Network Rail responses to Plumpton Parish Council questions are as follows: -

Figure 1: Estimated Collective risk by Crossing Type

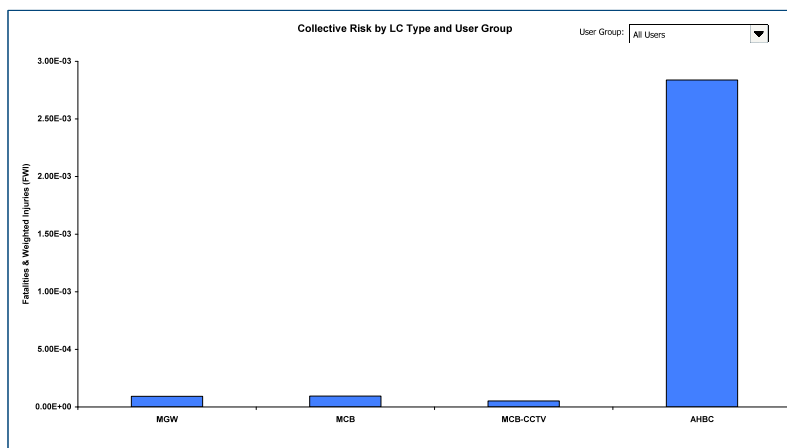
Q. When comparing the safety risk, what are the respective calculated risk values of each scheme? (proposed versus existing).

A. The current risk assessments show that the collective risk for the gated crossing is $9.21E-05$ FWI per year, and for the MCB-CCTV it is $5.25E-05$ FWI/ year – see below for a graphical comparison of various types of level crossing. These assessments are in the process of being updated with information from the census that was undertaken in September 2009: the results will be included in the study mentioned about.

Figure 2: Plumpton LC Census (14 to 20 Sept-09) Weekday Pedestrian Use

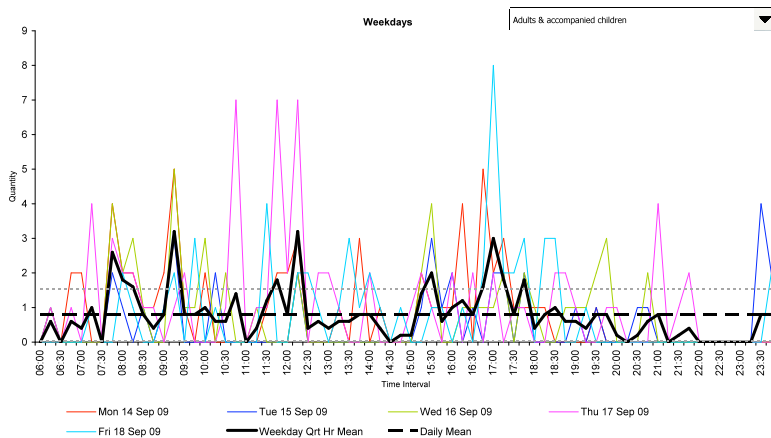
- Q. On race days, there is a high number of pedestrian users. What arrangements are proposed to ensure their safety? (RSP section 12 refers).
- A. Whilst the pedestrian use on race days is higher than other days, it is still low compared to other level crossings – see below. When designing a new layout for the crossing the pedestrian numbers and frequency of trains shall be considered, this will determine the footway widths and whether or not other measures to prevent pedestrians walking on to the road way are necessary, though the latter is probably not. Nonetheless, as stated above, consideration to manning the gate box on race days will be made.
